INITIAL FIRE SAFETY INSPECTION REPORT

Chorka Apparels Ltd. (Extension)

RSC ID: 24749

Date: 25-Jan-2024

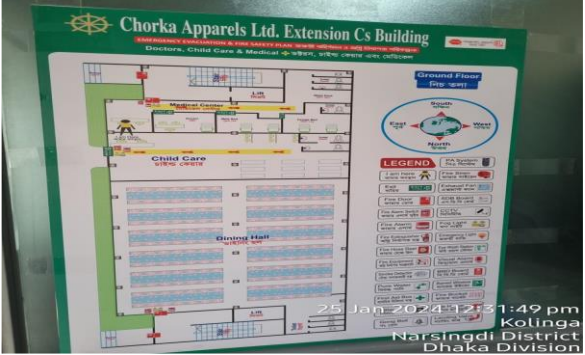
Sl No.	Category	Findings	Required Action	Remediation Time Frame
F-1	Fire Rated Construction	The exit stairs are not separated from work areas and other spaces on each floor by fire-rated construction due to non-functional fire doors. Fire doors were not interfaced with the fire alarm control panel. Also, Stair-2 is not seperated from waiting area of the medical room. Location: CS Building.	Provide minimum 2-hr fire rated separation in exit enclosures with minimum 1.5-hr fire rated doors and seal all unprotected openings and penetration to separate the exit stairs from work areas and other building spaces on all floor levels. Ensure that the fire doors are self-closing and positive latching and that they are provided with fire exit (panic) hardware where serving production floors. If fire doors are required to be held open for functional reasons, provide automatic closing devices tied to the fire alarm system.	Within 3 months

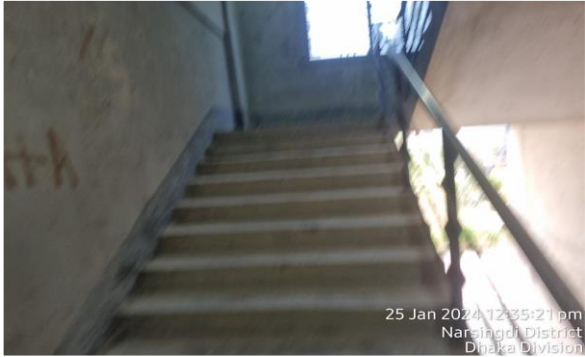
F-2	Fire Rated Construction	Elevator shaft is directly open into the exit stair enclosure which is a violation of RSC Technical Guidelines (Standard)-6.14.3. Location: Stair-1 enclosure of the CS Building.	Ensure the lift shaft is enclosed by a minimum 2-hour fire-rated wall with a minimum 1.5-hr fire-rated protective openings. An exit stairway shall not be built around a lift shaft unless both are located in a smoke-proof enclosure and made of a material with a fire-resistance rating required for the type of construction of a smoke-proof enclosure. (As per 6.14.3 of RSC Technical Guidelines (Standard) V1.0) Recommended to follow RSC "SUPPLEMENTARY PAPER ON REMEDIATION GUIDANCE ELEVATOR OR LIFT SHAFT OPENING IN EXIT ENCLOSURES" for remediation.	Within 3 months
